Board of Zoning Adjustment
Staff Report
January 7, 2019

Case No.	18CUP1113
Project Name	Bardstown Road Mini-Storage
Location	4401 Bardstown Road
Owner	Salt River Investment LLC
Applicant	Sterling Development LLC
Representative	Mindel Scott
Jurisdiction	Louisville Metro
Council District	2 – Barbara Shanklin
Case Manager	Beth Jones, AICP, Planner II

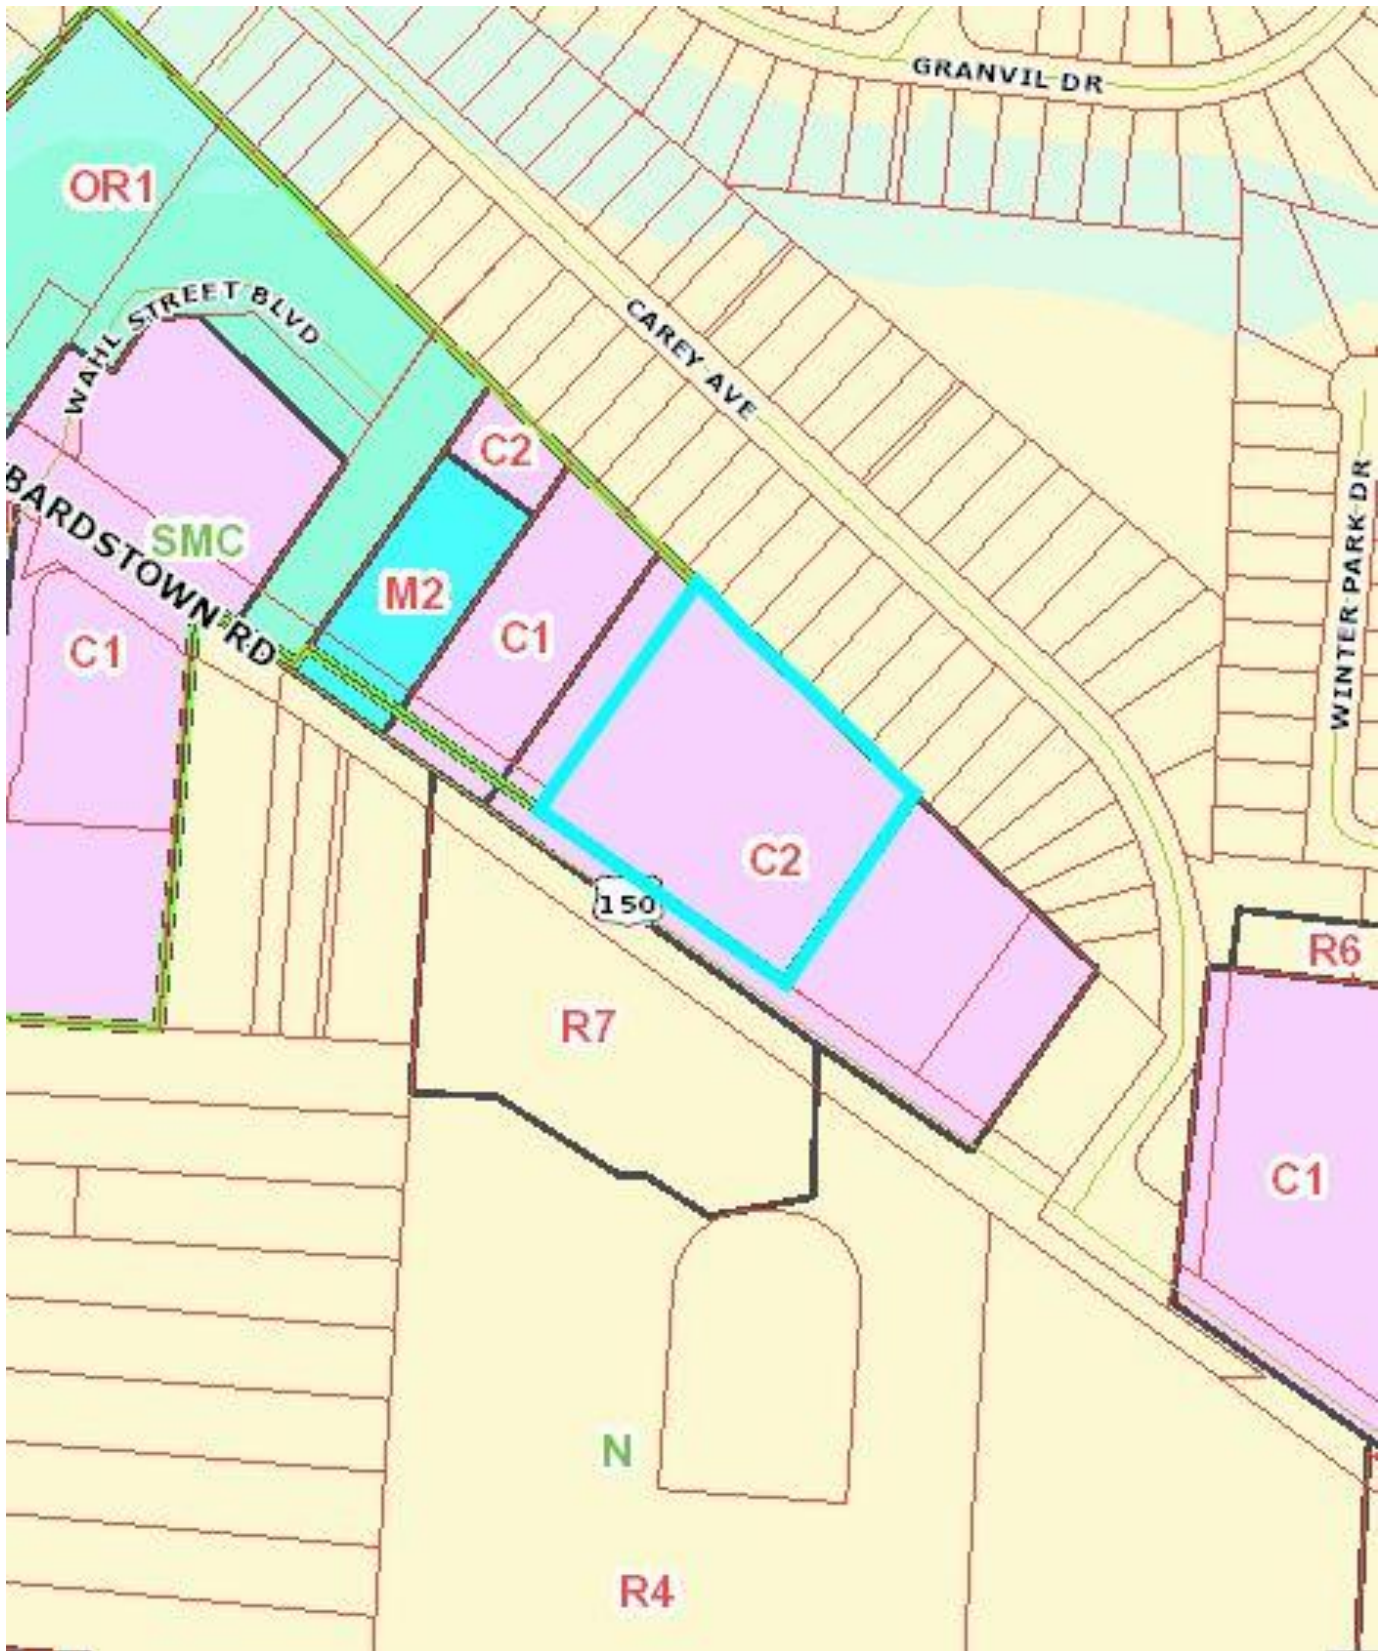
The waiver requests are not justified. If the applicant does not tie the property into the planned frontage street, it will result in separate access points for three individual properties, none of which will meet spacing requirements for sites located on a Major Arterial with a Median, rather than two driveways with the appropriate spacing (LDC Appendix 6A, Table 4) that will serve six sites. If these waiver requests are denied, the applicant will be required to submit a revised development plan.

Transportation Planning has declined to provide preliminary approval of the site plan, since the proposed development of the site does not tie into the existing frontage road system, which implements provisions of the Comprehensive Plan and meets established safety standards. The proposal fails to meet the applicable requirements of LDC 5.9 and LDC 6.1 or the standards of LDC Appendix 6A.

LDC Appendix 6A addresses standards including the number and location of curb cuts, which is to be determined in accordance with “this manual, AASHTO [American Association of State Highway and Transportation Officials] standards and good engineering practice”. The site frontage is not sufficient to meet the minimum 600 ft driveway spacing on a Major Arterial with a Median with a speed limit of 45 mph or more (LDC Appendix 6A, Table 4). This spacing standard would require a minimum distance between the two existing frontage road access points of 1,200 ft; the actual distance is approximately 790 ft.

The waiver justification states that construction of the frontage road is an unnecessary hardship due to the cost of construction. The potential cost to a developer should not outweigh safety standards established by the LDC, AASHTO and good engineering practice. As the frontage road connections on the adjoining properties were in place prior to the applicant's submittal of the proposal, it should have been apparent that a connection would be required. Furthermore, an existing binding element for the previously-approved development plan (13ZONE1016) requires the easements that would be necessary in order to complete the frontage road existing on the nearby properties.

In addition, a preliminary plan submitted by the applicant on October 15, 2018 includes a frontage road connecting to the frontage street stubs on adjoining sites that meets LDC requirements. This plan was subsequently removed from consideration by the applicant.

2. Any revision of the development plan as submitted to BOZA to be reviewed by the Planning Commission or its designee must include construction of a frontage street which connects to the existing interior vehicular circulation system at 4335 Bardstown Road and 4405 Bardstown Road. No direct access from Bardstown Road to the subject site shall be permitted.
